PROJECT: Butler High School Turf Field Replacement

This **Addendum #1** consists of **4 pages for addendum form (not including attachments) with 2 attachments of 7 total pages for attachment (Rev Bid Form and Sheet 1 of 1 Drawing)**

**BUTLER HIGH SCHOOL
TURF FIELD REPLACEMENT**

**Addendum Plan
Existing Conditions**

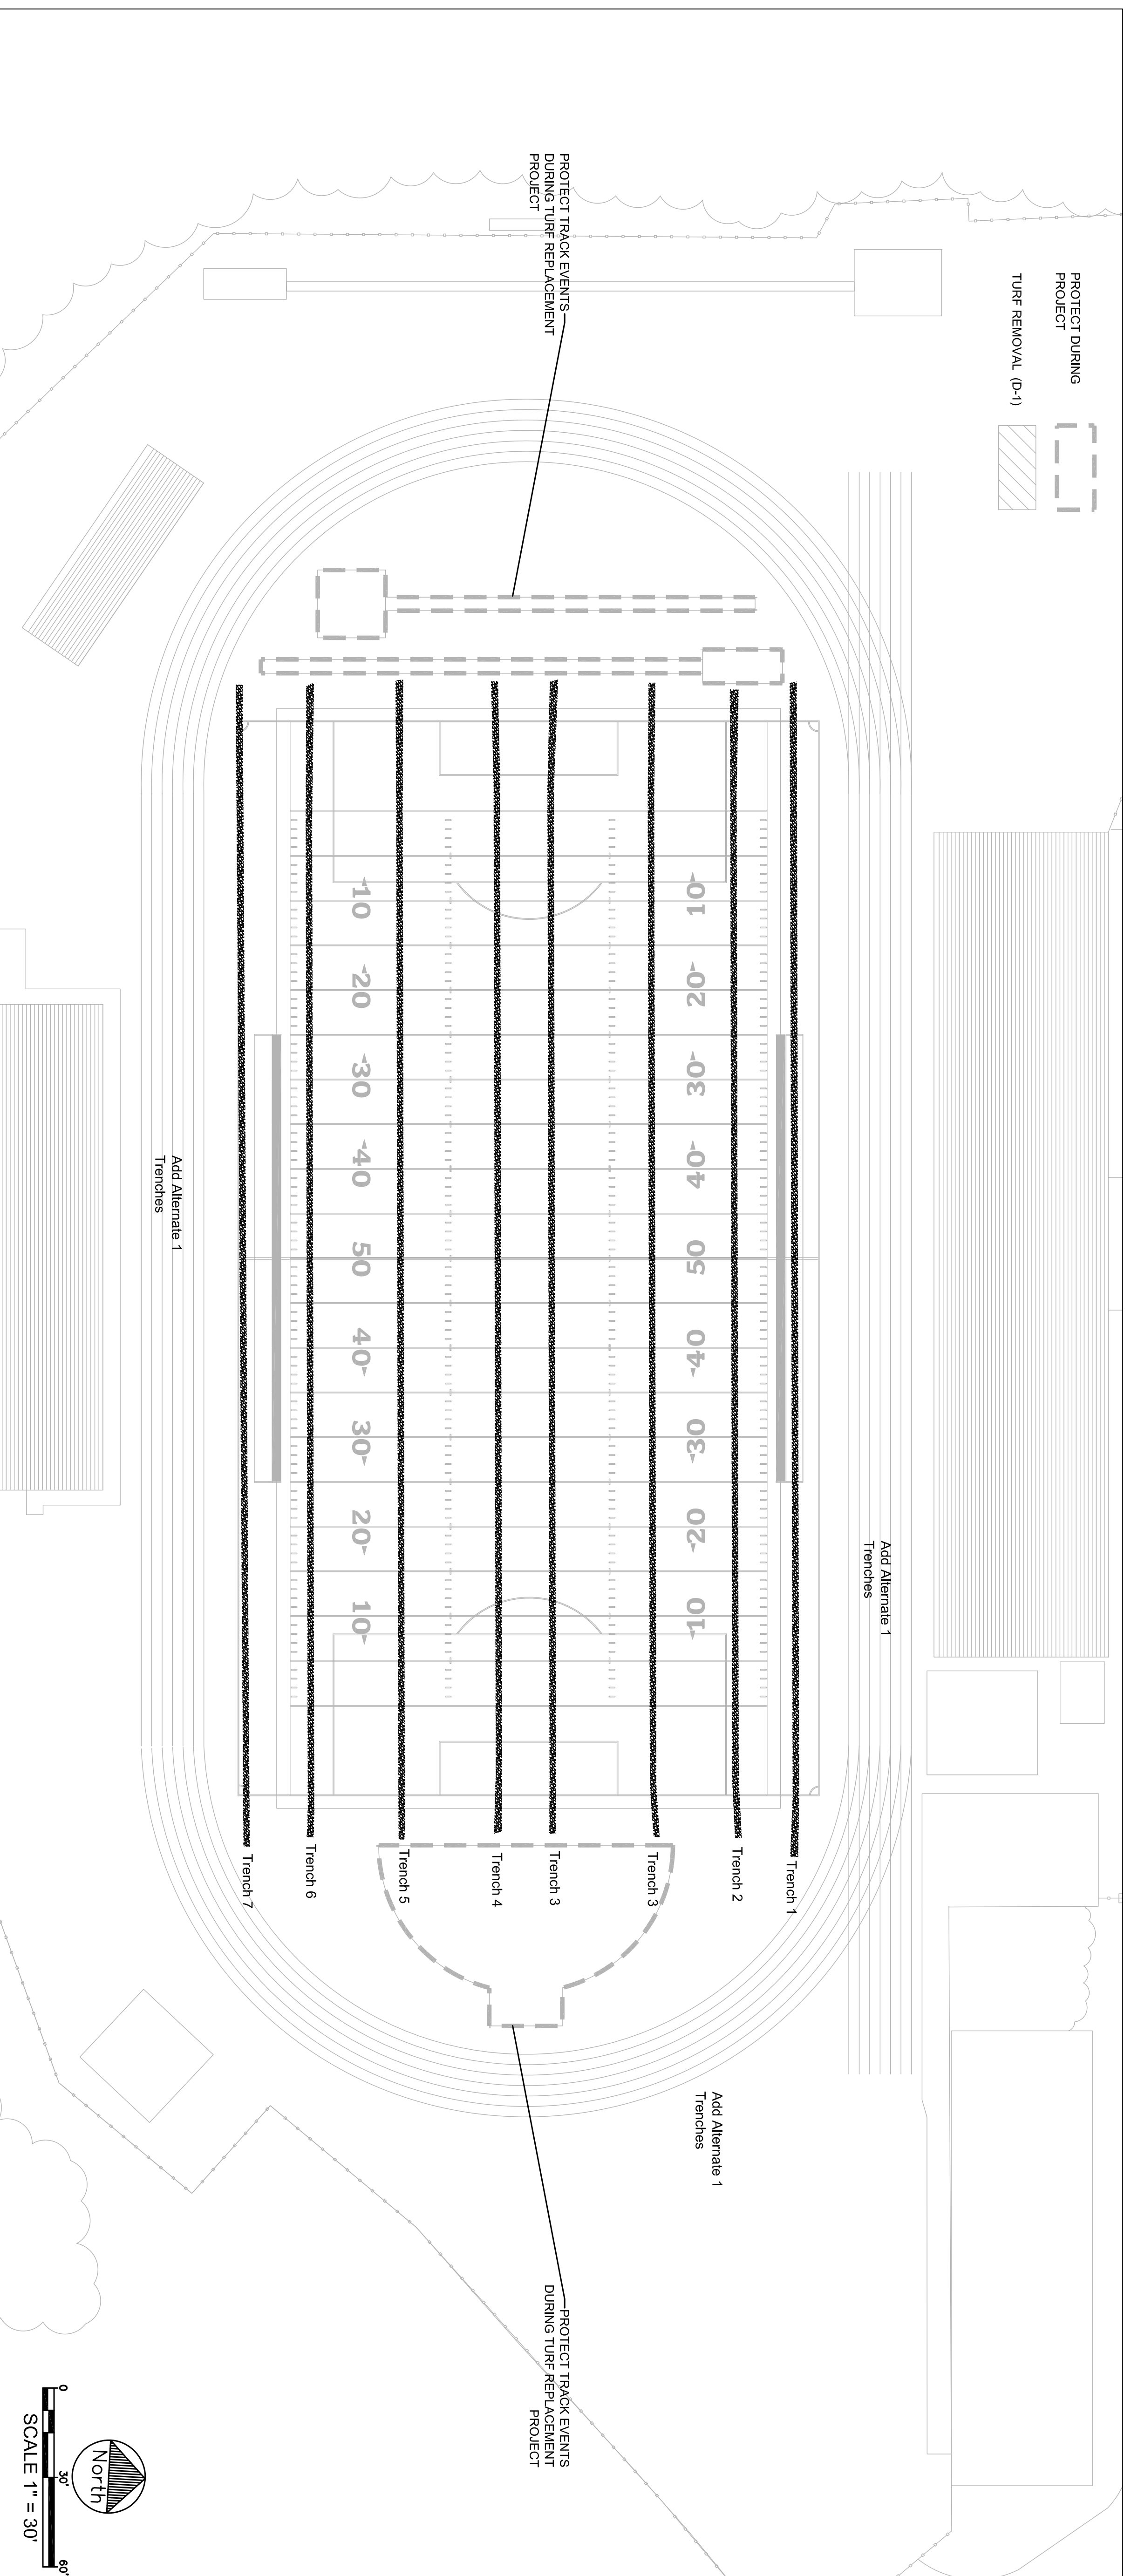
Remove 3 inches of fine material at location shown above for Trenches 1 through 7 (1,2,3,4,5,6,7).
Replace with #8 limestone and compact. Trench width shall be 12 inches and its length as shown on plans. Spread #9 stone over top and even grade. Water trench to full saturation and/or allow for up to two rain events on trench. Then compact and check final grades to avoid settlement.

Remove 3 inches of fine material from total limits of field and replace with 2 inches of #57 clean limestone and 1 inch of #9 clean limestone on upper layer and fine grade.

BASE BID: Provide 0.5" of #9 clean and washed limestone over field to even field and provide smooth finish.
